DRB Final Sign-off of Major Amendment approved by EPC for development of a car wash at 10084 Coors Blvd NW

**RE: Cottonwood Crossing Car Wash  
10084 Coors Blvd NW  
Conceptual Grading & Drainage Plan  
Engineer's Stamp Date: 06/15/21  
Hydrology File: B14D010C**

**Project #2021-005816**  
**SI-2021-01684, VA-2021-00363**  
Site Plan Major Amendment and Variance-EPC

Re: Cottonwood Crossing Car Wash Final Site Plan Sign-off

8 ACCESSIBLE PARKING SIGN  
SCALE: 3/4" = 1'-0"

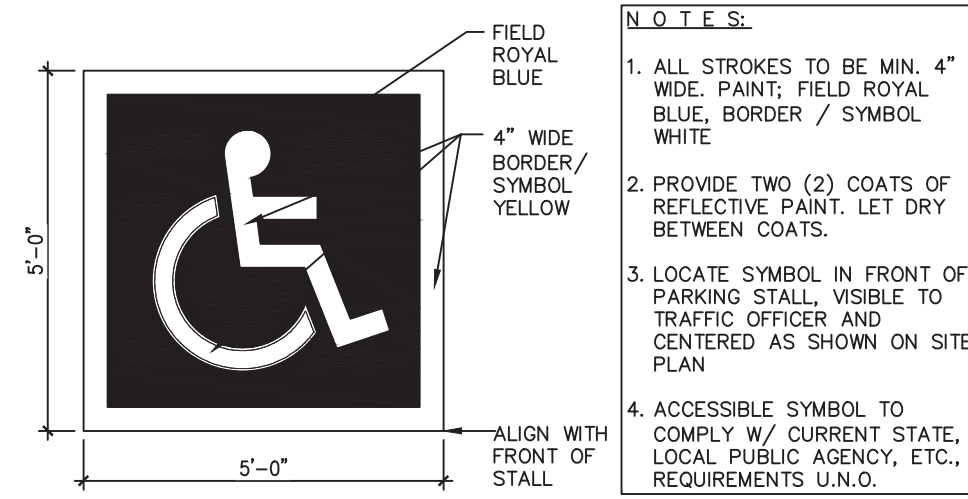
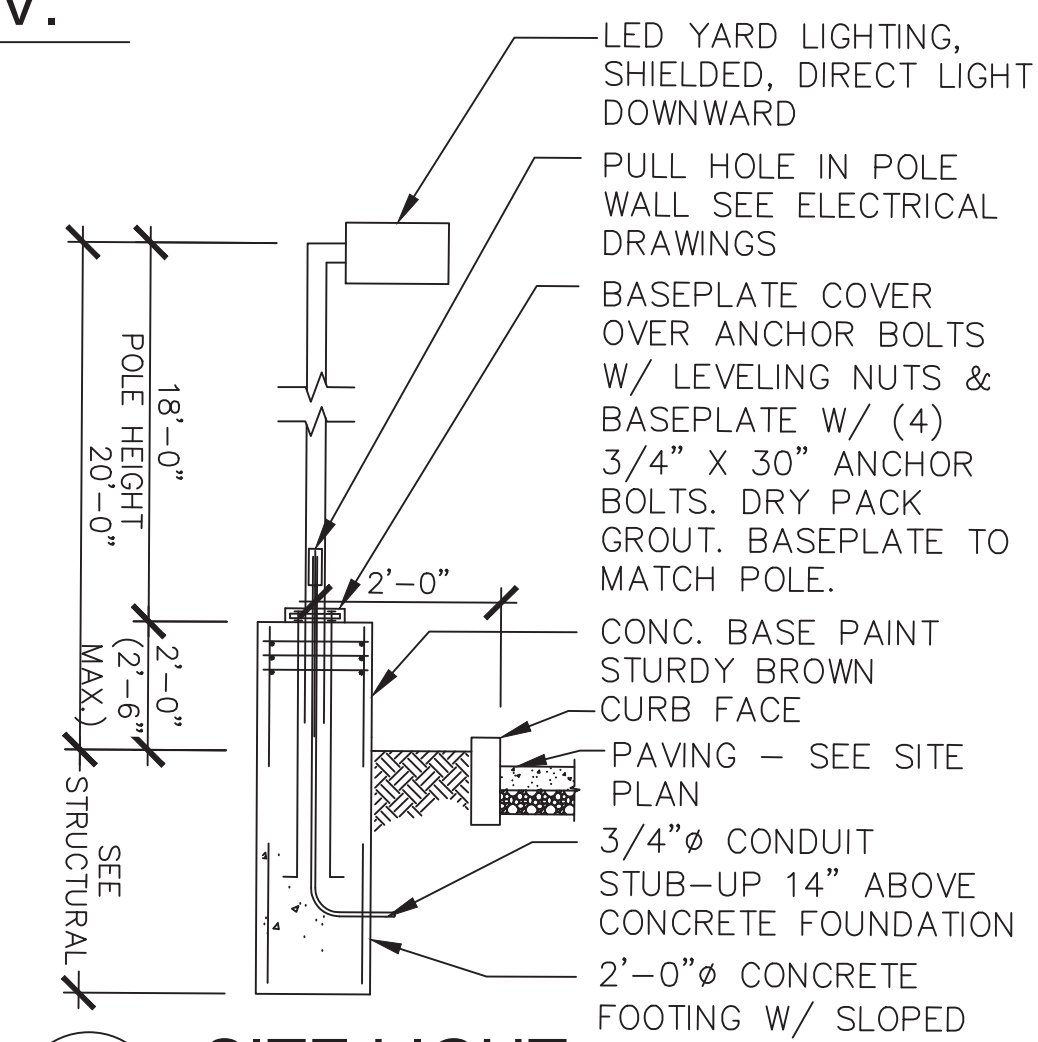
6. Bicycle and motorcycle calculations shall be incorporated into the design and all parking calculations shall be revised.
7. Conditions from the Transportation Development Review Services shall be addressed.

*Bicycle parking has been added near the building entrance and a motorcycle space has been added adjacent to the ADA parking. Appropriate details for each have been added to the detail sheets.*

1 SOUTH ELEVATION (CAMELBACK)  
SCALE: 1/4" = 1'-0"

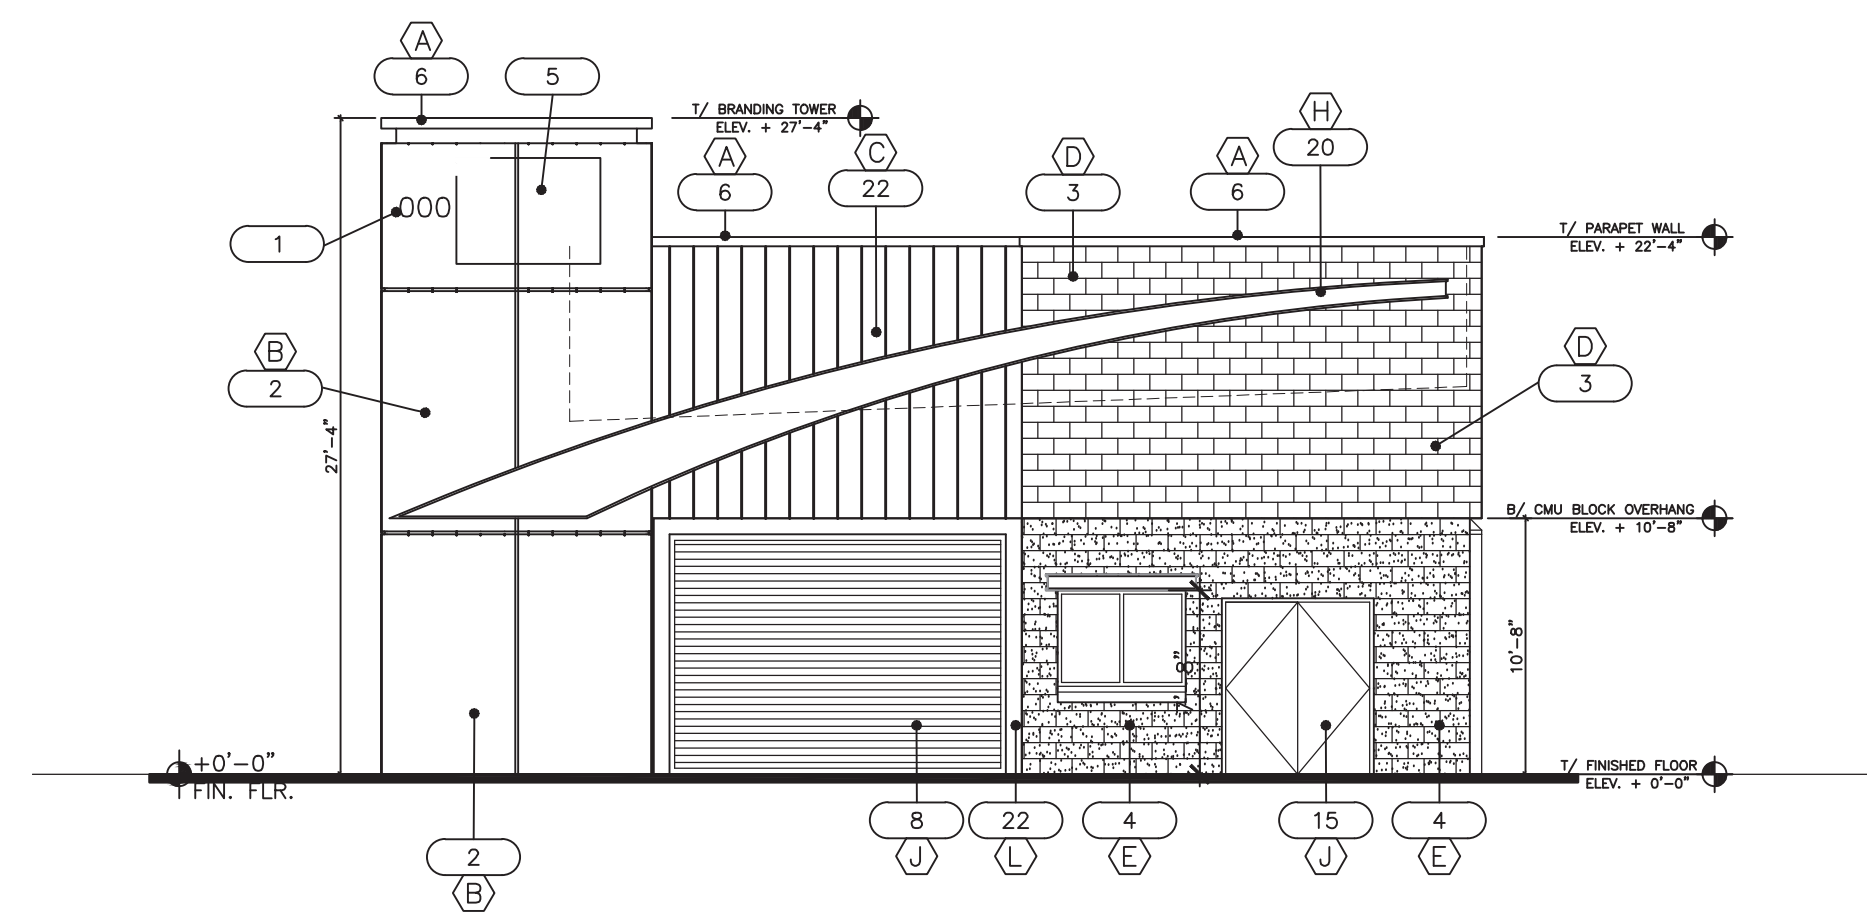
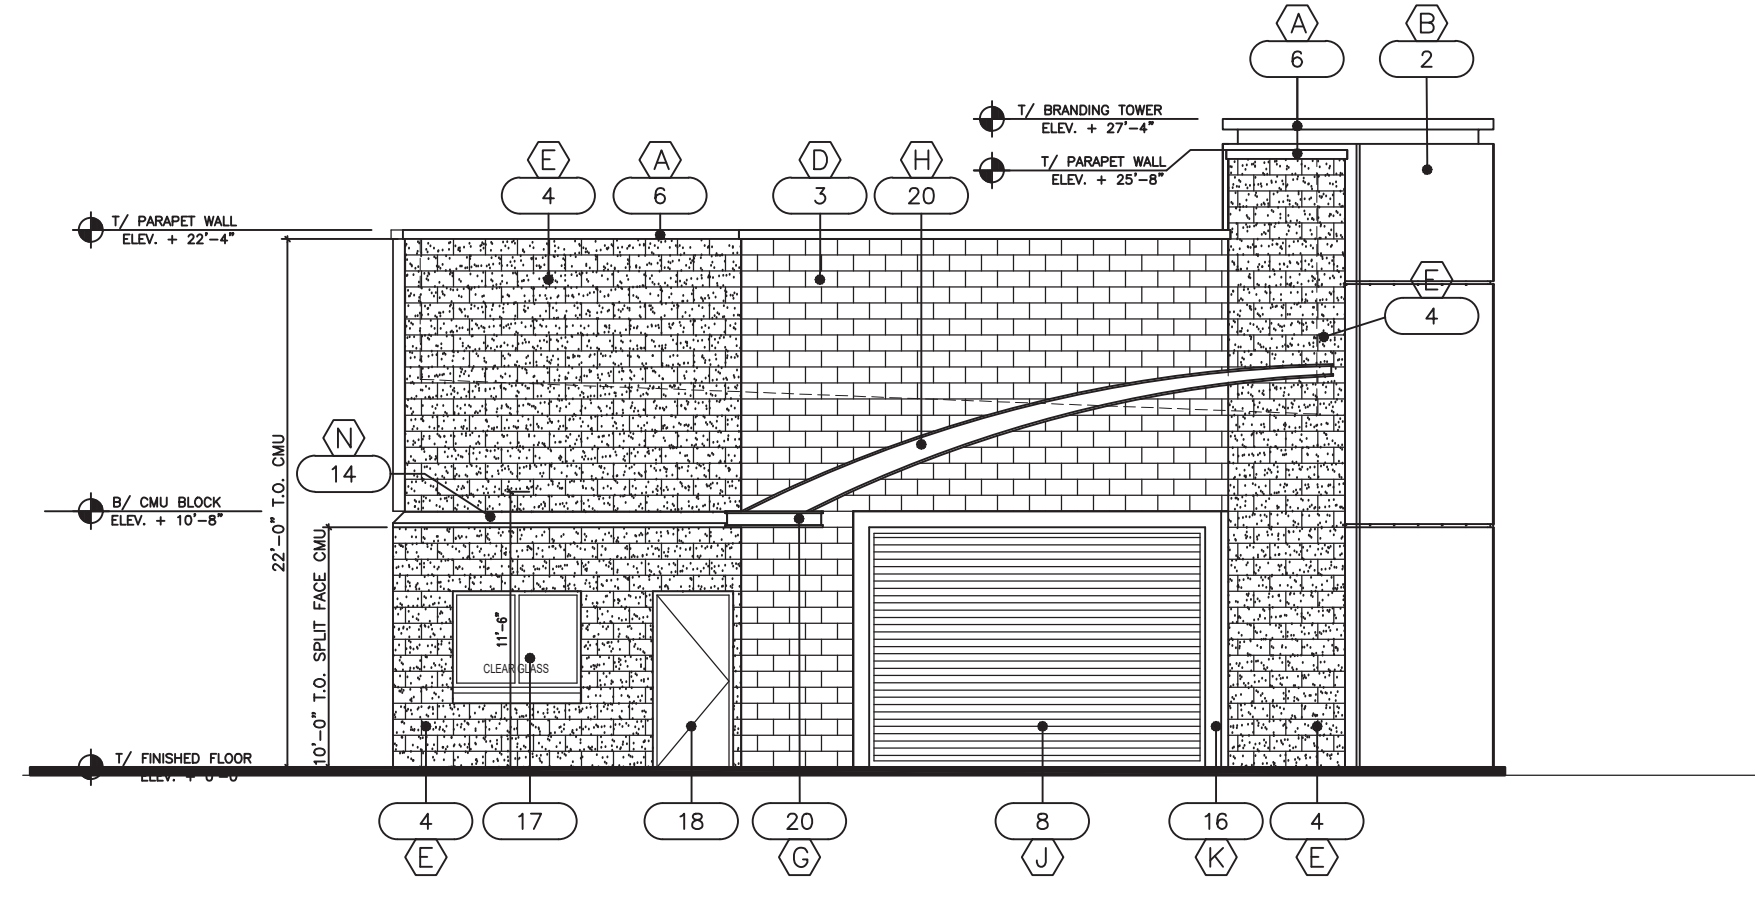
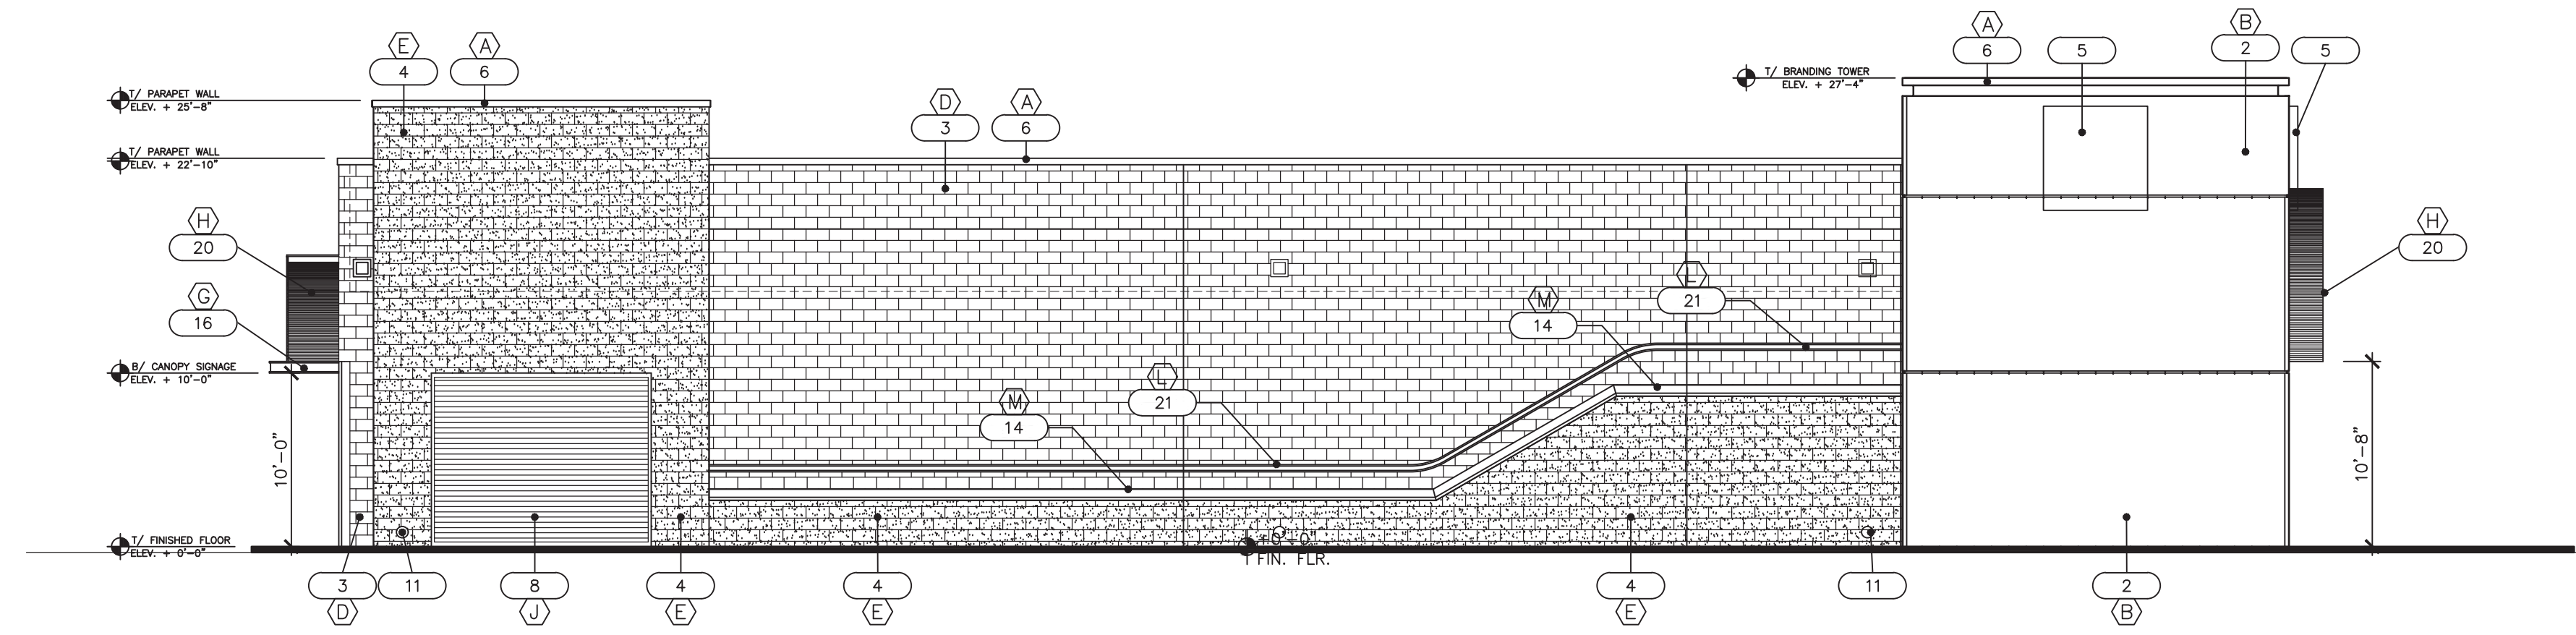
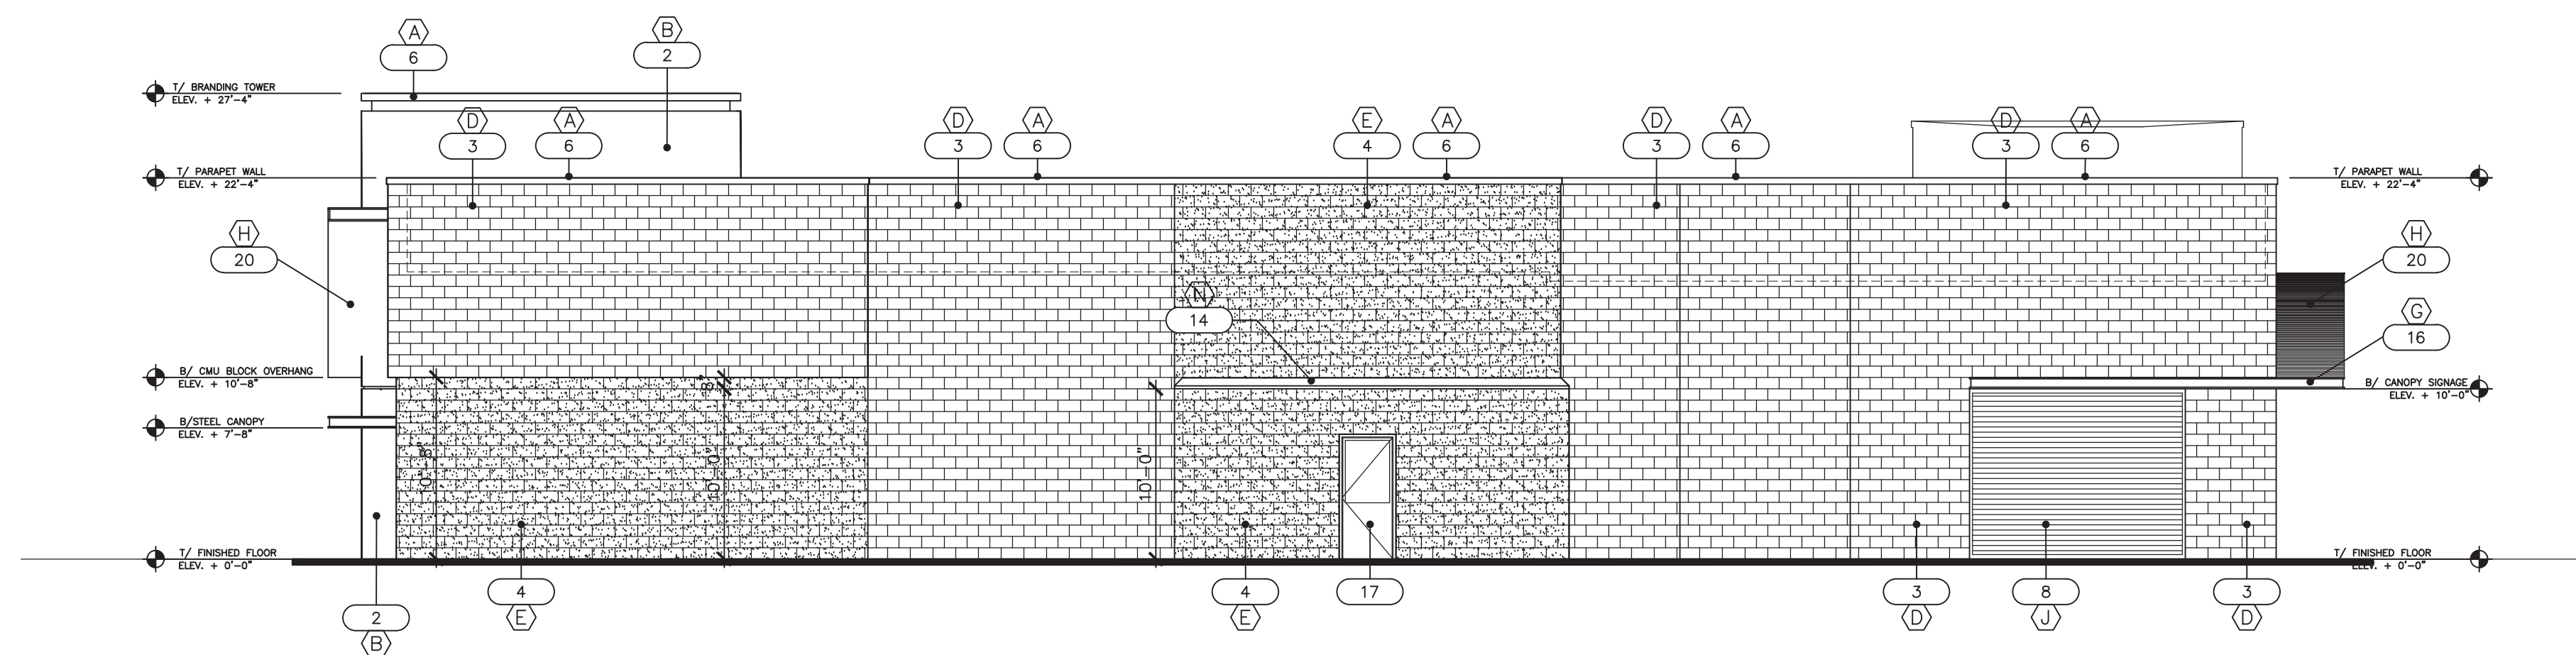
4. The branding tower shall meet the VPO-1 requirement and shall be lowered to a maximum height of 27'-4".
5. Signage – Provide monument sign detail if a monument sign is proposed. The detail shall be dimensioned and shall specify colors and materials. Provide detail for the “prefabricated illuminated aluminum accent” that is to be placed 10'-8" above the finished floor elevation. The details shall include height, width, square footage of the sign face, colors, and materials at the time of DRB submittal.

*The building elevations have been revised to lower the height of the building to 27'-4" as required.*
